Review of IAF application

Stormwater Enabling Works

Prepared for
Rotorua Lakes Council

Prepared by
Tonkin & Taylor Ltd

Figure 3.1: Flow conversion in the Lower Utuhina Stream.

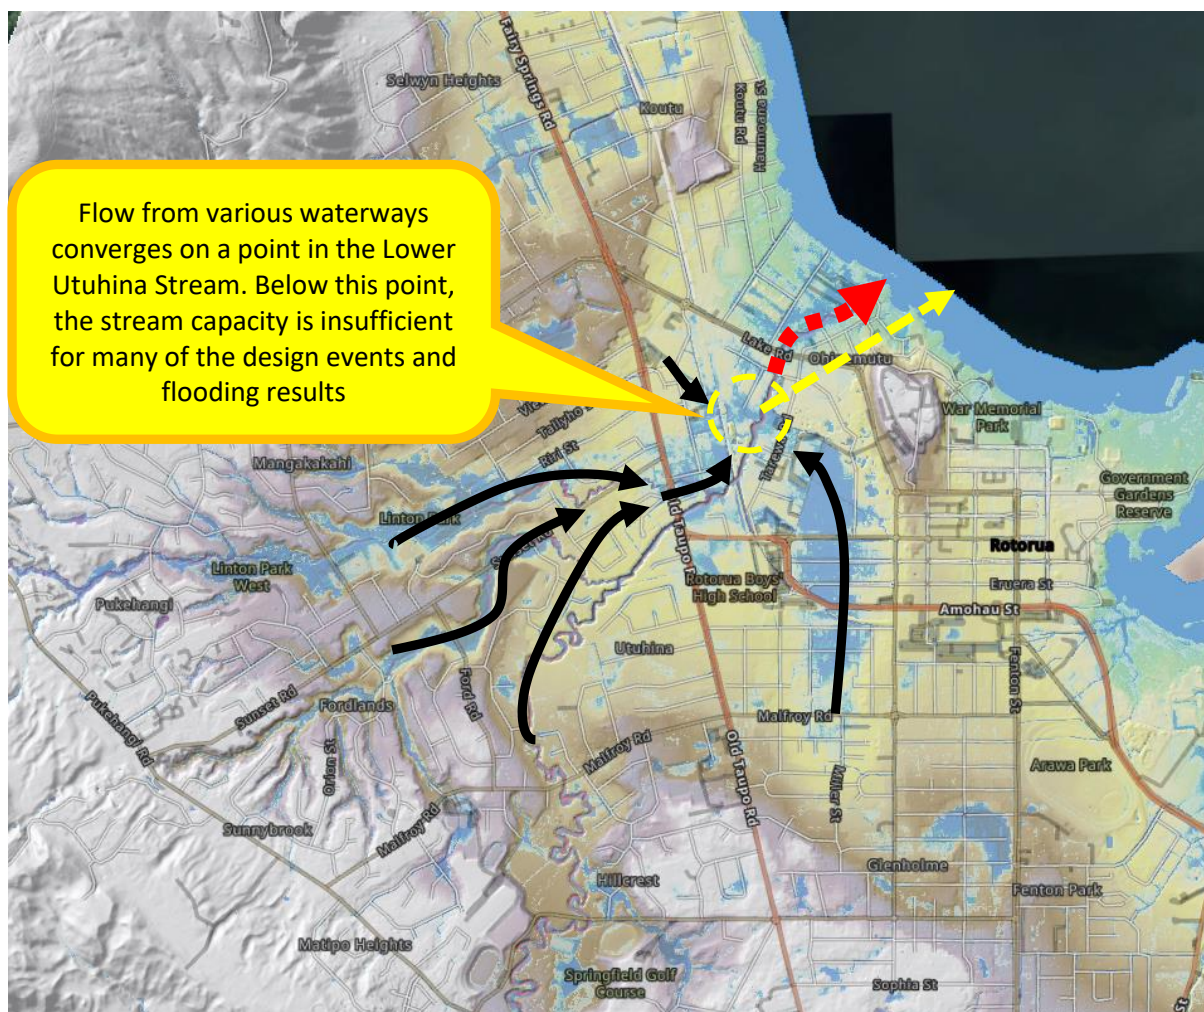
Flooding is an issue that is widely recognised in the Lower Utuhina Stream area. Examination of the contributing catchments shows there to be several waterways or drainage paths that converge on the stream, at a point about where the flow gauge off Depot Street is located. This is shown by the yellow dashed circle in Figure 3.1. Downstream of this, the waterway is constrained laterally by existing, historic development with little opportunity to widen the stream. Given the contributing area, an increase in outflow capacity from this point to the lake would potentially “free up” development elsewhere in the city.

We suggest that it would be worthwhile undertaking a feasibility type investigation into how this additional capacity may be able to be formed. With additional capacity there would be less reliance on upstream detention to mitigate peak flows, with those areas currently required for detention being potentially freed up for other use.
